A d d e n d u m

Iowa Department of Transportation
Office of Contracts

Date of Letting: December 17, 2013
Date of Addendum: December 16, 2013

B.O.	Proposal ID	Proposal Work Type	County	Project Number	Addendum
104	57-1557-638	PCC PAVEMENT WIDENING	JOHNSON	STP-U-1557(638)--70-52	17DEC104.A02

ENGLISH	IOWA DOT	DESIGN TEAM	HR Green, Inc.	CITY OF CORALVILLE	JOHNSON COUNTY	PROJECT NUMBER	STP-U-155716381--70-52	SHEET NUMBER	P.05	REVISED
11:26:51 AM	14.DOT	\\irgcrmas\data\CD\1939500\Design\1939500\F01.rvt

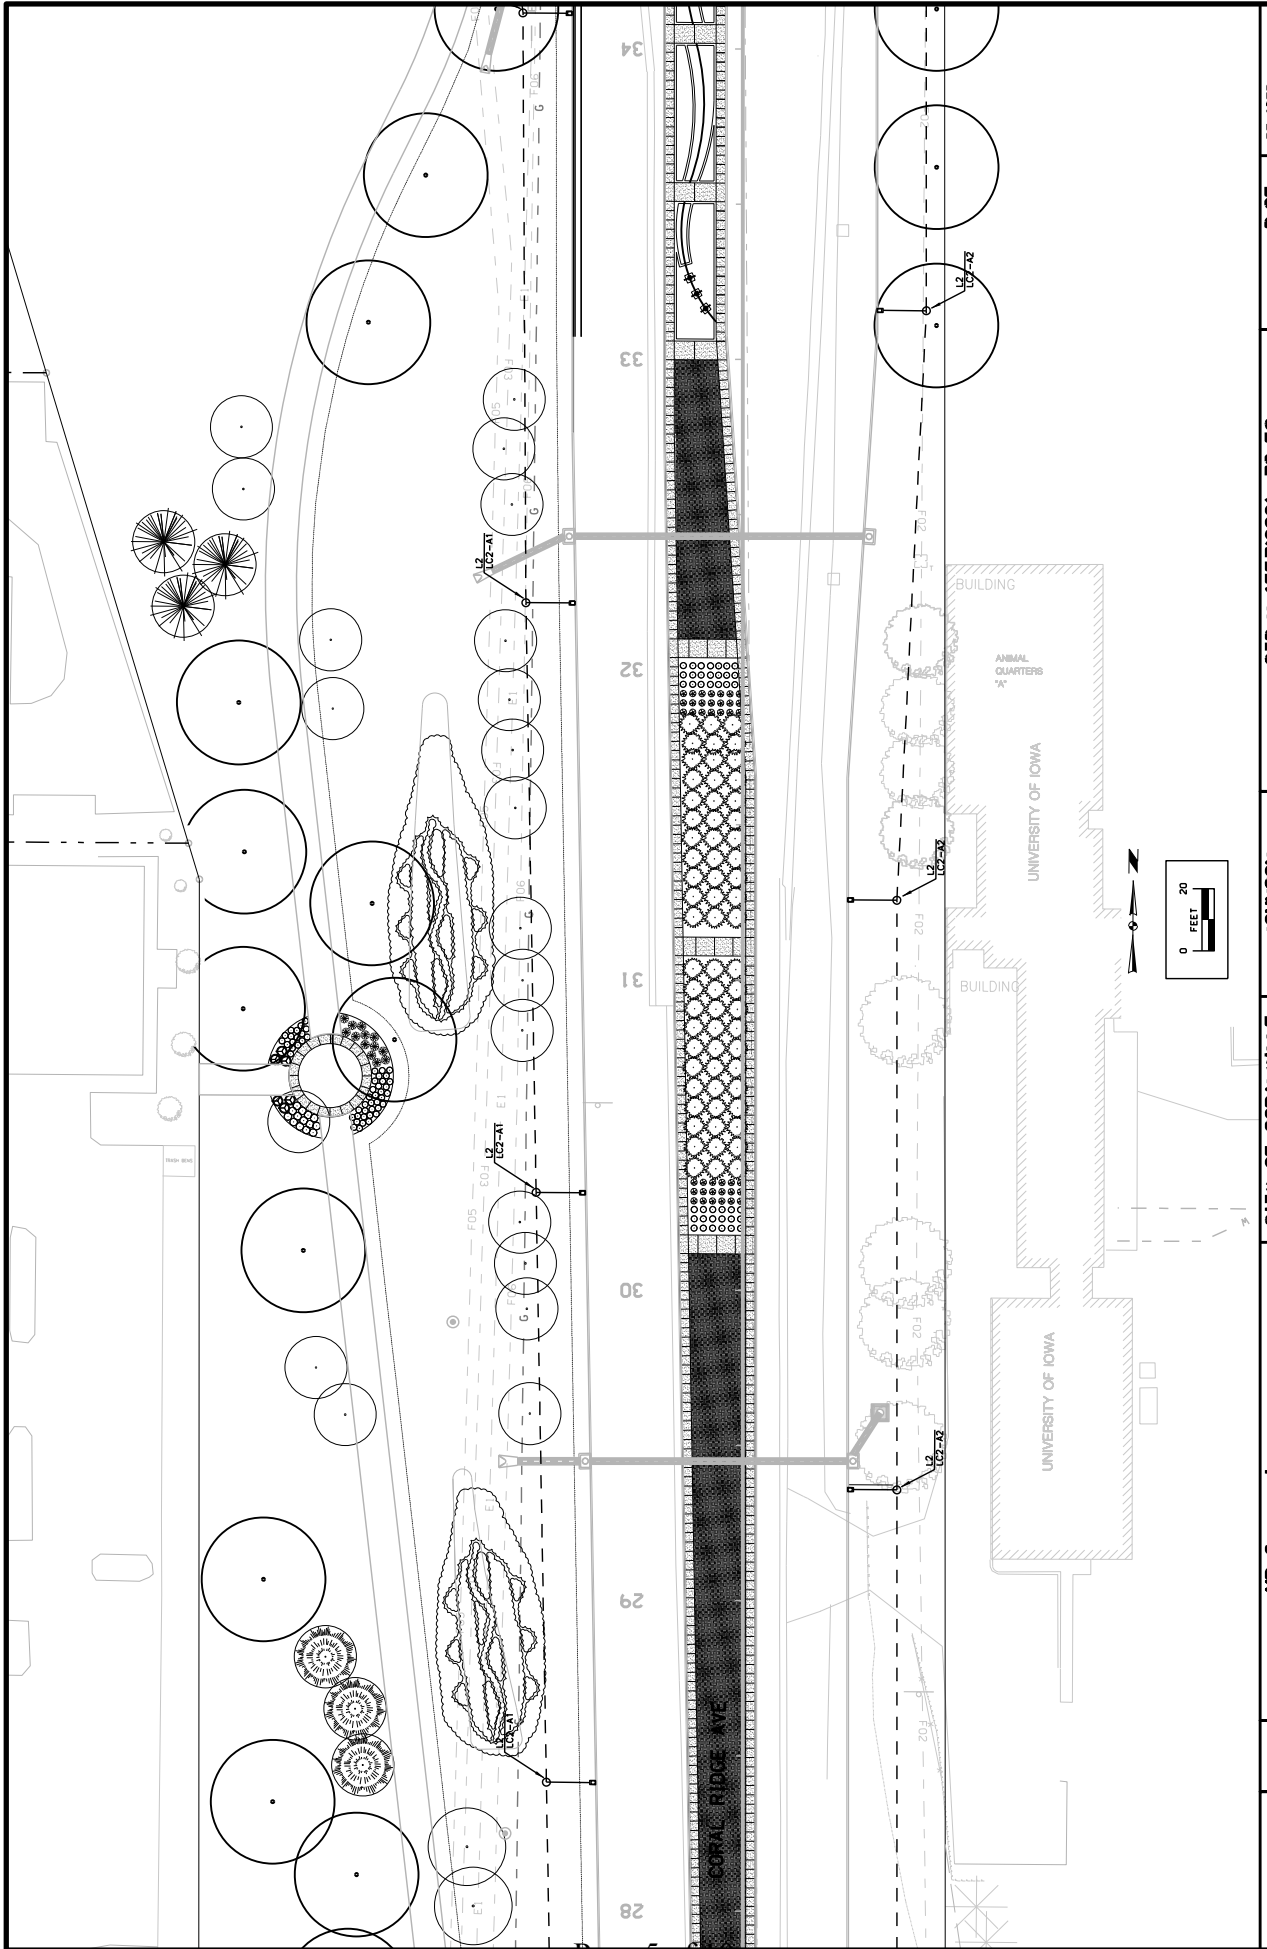
Make the following changes to plan sheets P05, P06, P08, and P09:

Change the mark on roadway lighting unit at approximate Sta 33+15 RT from L1 to L2.

Change the mark on roadway lighting unit at approximate Sta 34+50 RT from L1 to L2.

Replace plan sheets P.05, P.06, P.08, and P.09 with attached plan sheets P.05, P.06, P.08, and P.09.

UNIT L2 FOUNDATION DETAIL
NOT TO SCALE

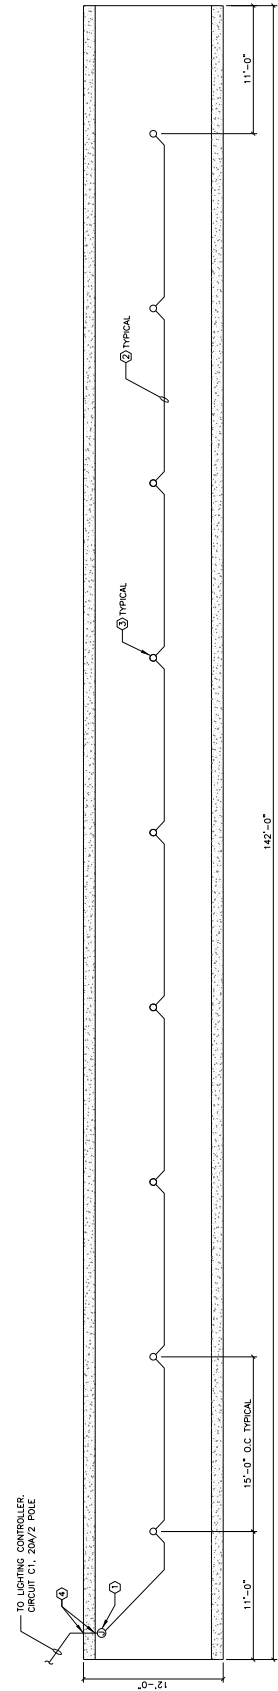
Change the note referring to the circuit conduits for the Unit L2 Foundation Detail on Sheet P.09 to read:

PVC CONDUIT TO LIGHTING UNIT, SIZE AS PER PLANS

PROJECT NUMBER
COUNTY
CITY OF CORALVILLE
JOHNSON
SIP-U-1557(638)-70-52
SHEET NUMBER
W.7
REVISED

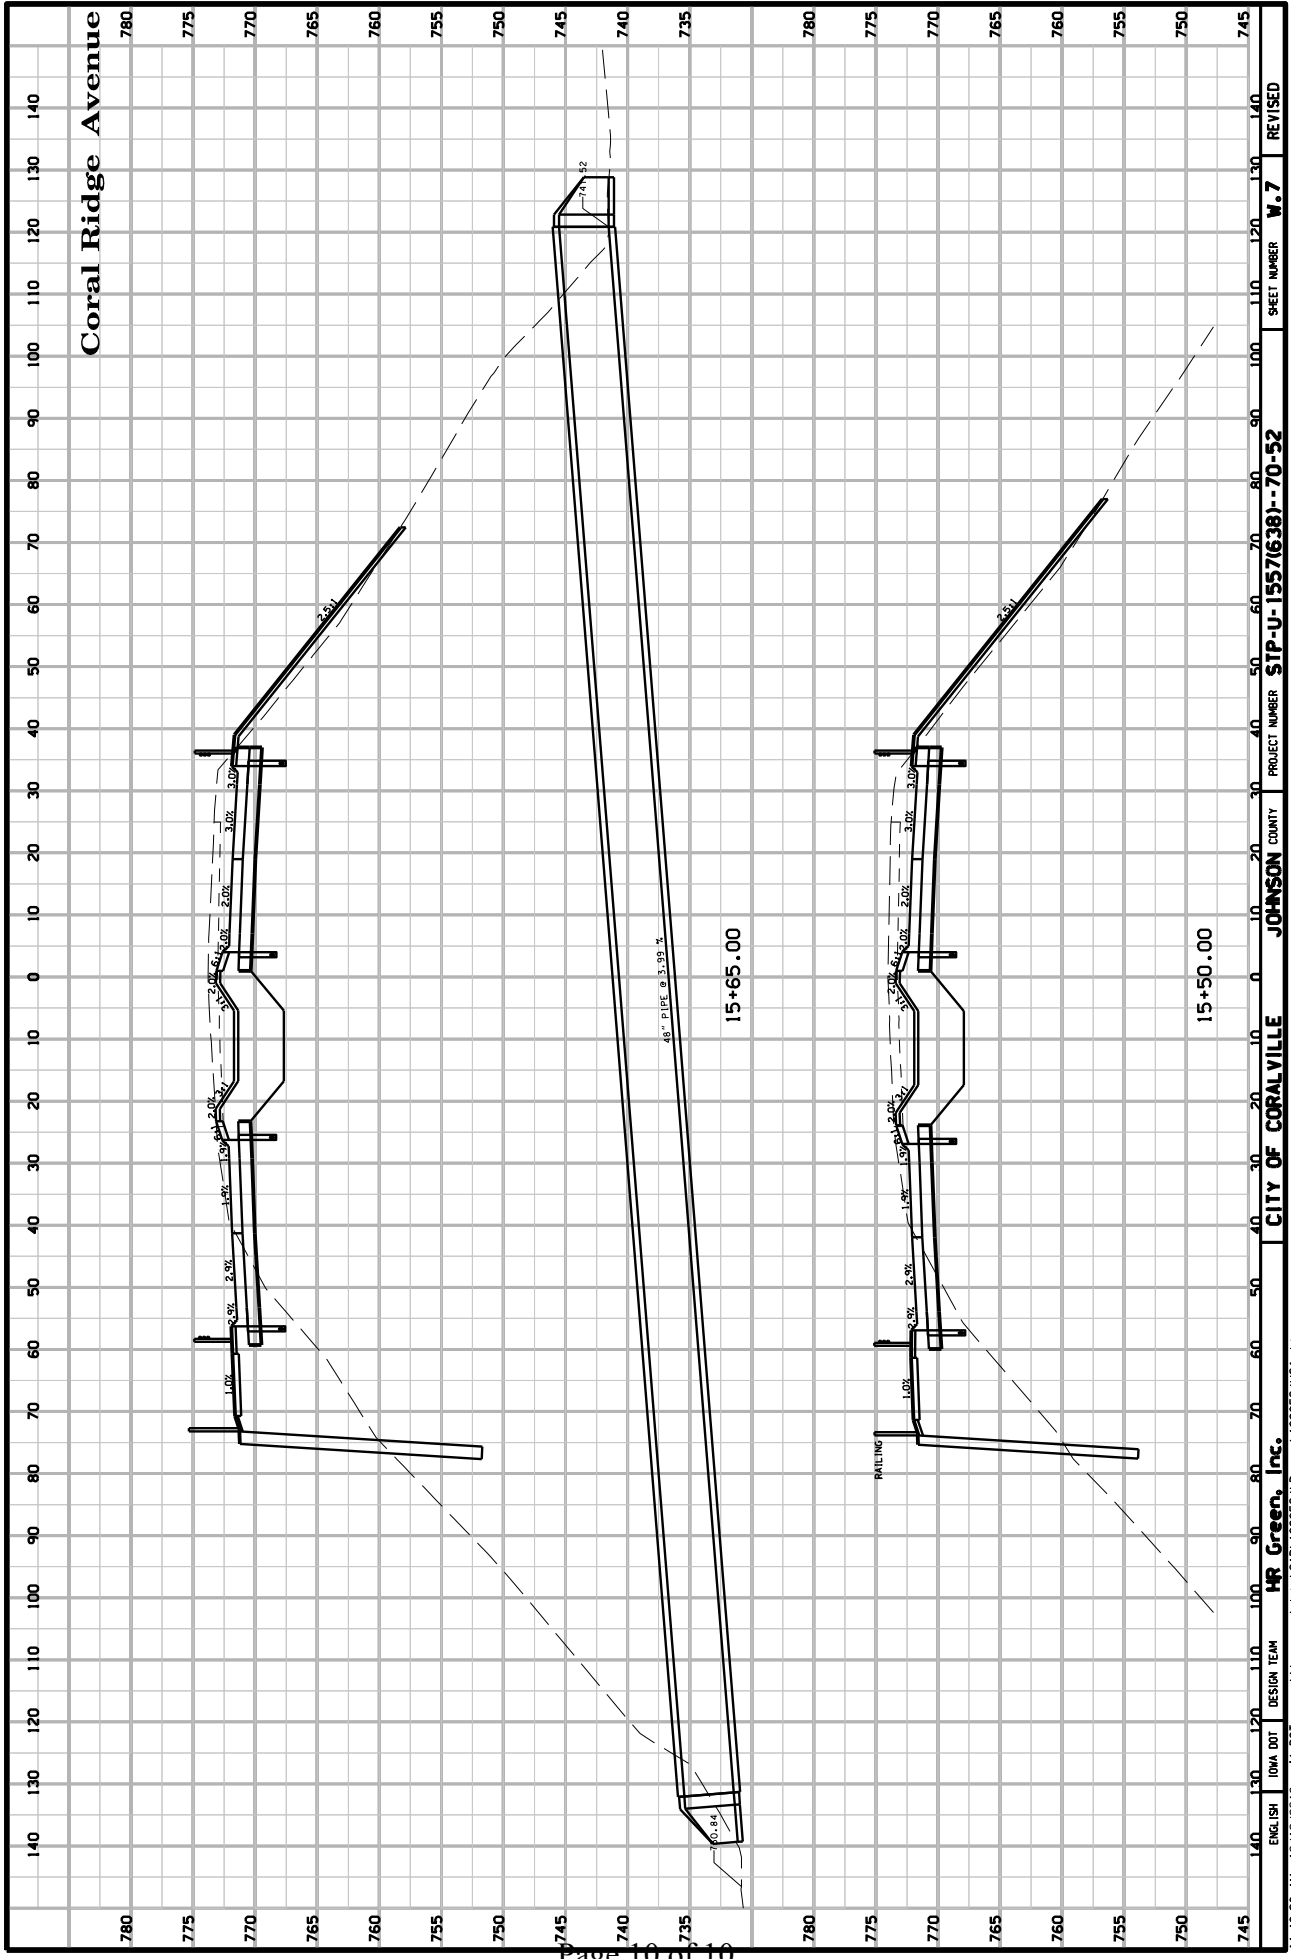
Make the following changes to plan sheet W.07:

Change the location of the retaining wall in the cross-section at Sta 15+65. The front face of wall is approx. 75 feet left of centerline.

Replace plan sheet W.07 with attached plan sheet W.07.
